# Staff Report

**REPORT NO.:** DSD-2025-169

**SUBJECT:** Minor Variance Application A2025-042 – 1100 Union Street  
Consent Application B2025-013 – 1100 Union Street

**Figure 4: Proposed Lot Fabric  
(Severance Sketch prepared by Grit Engineering Inc.)**

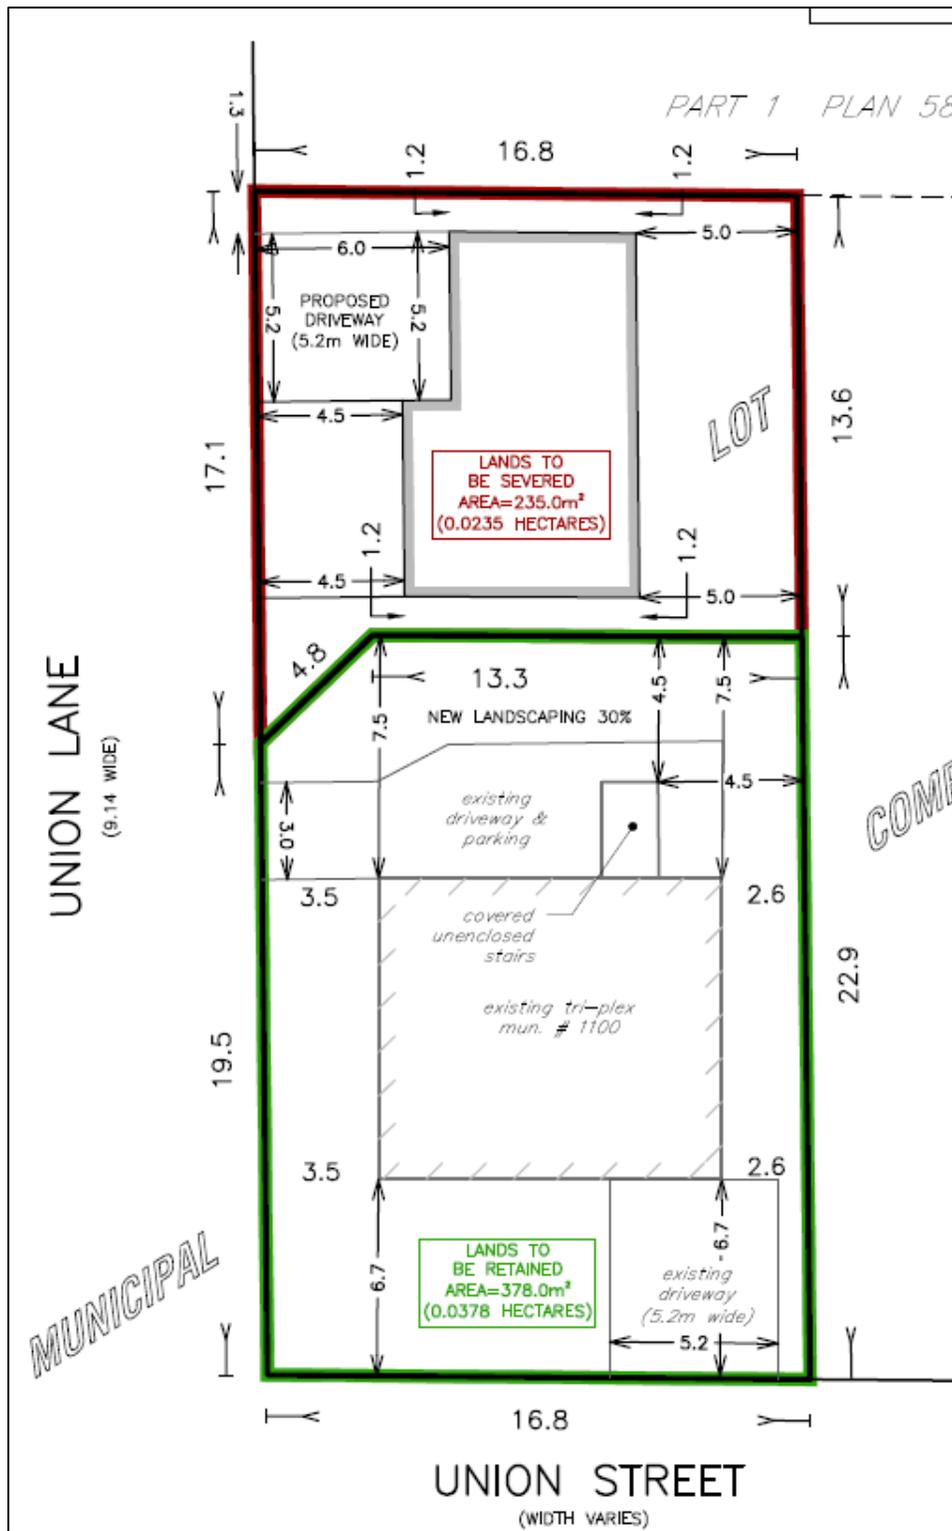
The Applicant and Owner were also requested to demonstrate the functionality of the Retained Parcel with the existing 'Triplex' dwelling; that all zoning by-law regulations, including parking, landscaping, unobstructed walkways, could be met. They were also advised that the drawing did not represent the 'as built' condition as an existing covered stairway on the rear fascia was not shown.

The Applicant continued to submit a drawing with the application that did not show the existing covered stairway on the rear fascia of the existing triplex. The drawing also did not demonstrate the functionality of the 'Triplex' Dwelling on the Retained Parcel particularly with respect to the location of required unobstructed walkways, their relationship with the existing entrances and their intersection, if any, with driveways/parking spaces. The rear landscaped area was noted as 30% but without the required walkways shown it is not known whether this requirement is met. Also, it could not be confirmed that the minimum front yard landscaped area would be 20%.

On a site visit, it was noted that there are existing walkways at the front of the building and at the side and to the rear were not reflected on the drawing that was submitted with the application.

Since the applications were originally submitted, the drawing has been updated to only reflect the existing covered stairway on the rear fascia and it has been included in this report as Figure 4.

With respect to the 'Retained Lands', the drawing, submitted with the Minor Variance and Consent Applications did not demonstrate the zoning compliance or functionality of the 'Triplex' Dwelling on the Retained Parcel particularly with respect to the location of required unobstructed walkways, their relationship with the existing entrances and their intersection, if any, with driveways/parking spaces. The rear landscaped area was noted as 30% but without the required walkways shown it is not known whether this requirement

is met. Also, it could not be confirmed that the minimum front yard landscaped area would be 20%. Also, there is a loss of amenity area for the 'Triplex' dwelling to create a lot that does not have frontage on a street. The resultant amenity area for the 'Triple' dwelling or use thereof, has not been clearly identified.
